Project Ref: ERC0394

AEMC Improving the NEM access standards - Package 2: Draft Determination

Transgrid's response to AEMC's Improving the NEM access standards – Draft Determination

Figure 1: Voltage ride-through envelope

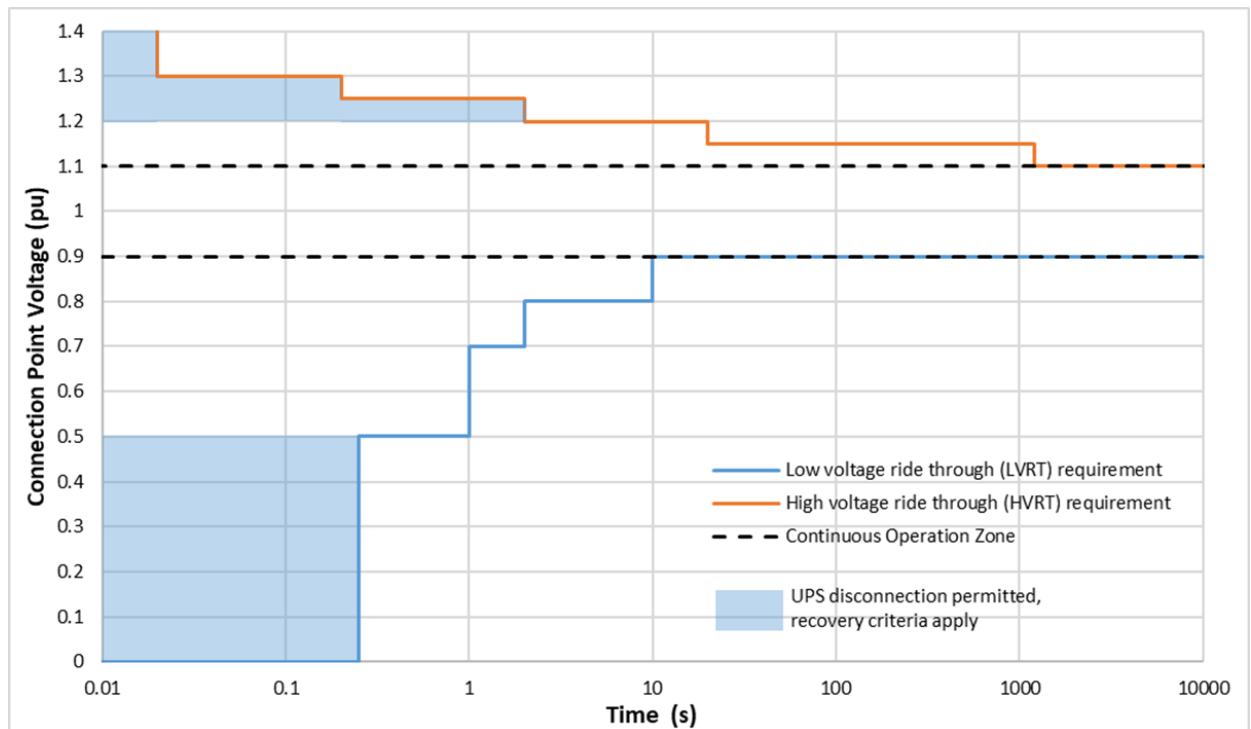
1. Aligning the overvoltage ride-through requirements with S5.2.5.4 for Schedule 5.2 plant. Part of this could be classified as "Region C", permitting disconnection of plant (e.g. data centre UPS) provided the post disturbance recovery criteria is met.

2. Considering system standard clearing times for breaker fail protection system when setting deep disturbance duration requirements.

Figure 1 shows an example voltage ride-through curve that accommodates Transgrid's recommendations above. We have engaged with multiple data centre customers on this proposal and believe that while it does set a high standard, it is technically feasible for a data centre to meet this. Provided the minimum access standard includes sufficient room to negotiate where plant cannot meet this, we believe it is appropriate to set a high standard for the automatic access standard. Specific points to note with respect to Figure 1 include:

- The high voltage ride-through requirement aligns with NER S5.2.5.4 (noting that the high voltage ride-through performance above 130% presented in the below figure will be updated to align with the most recent rule change for generators).
- The low voltage ride-through requirement for connection point voltages down to 0.7 p.u. aligns with NER S5.2.5.4.
- The deep disturbance requirement is based on 330 kV breaker fail protection system clearing time of 250 ms and includes a requirement to ride-through voltage disturbances of 0.5 to 0.7 p.u. for a period of 1 second. This was based on analysis of the likely voltage disturbances caused by remote faults in the 132 kV system, which may not be cleared in 250 ms.
- Permits plant to disconnect if the connection point voltage falls below 0.5 p.u. or increases above 1.2 p.u. Recovery criteria would apply in this case.
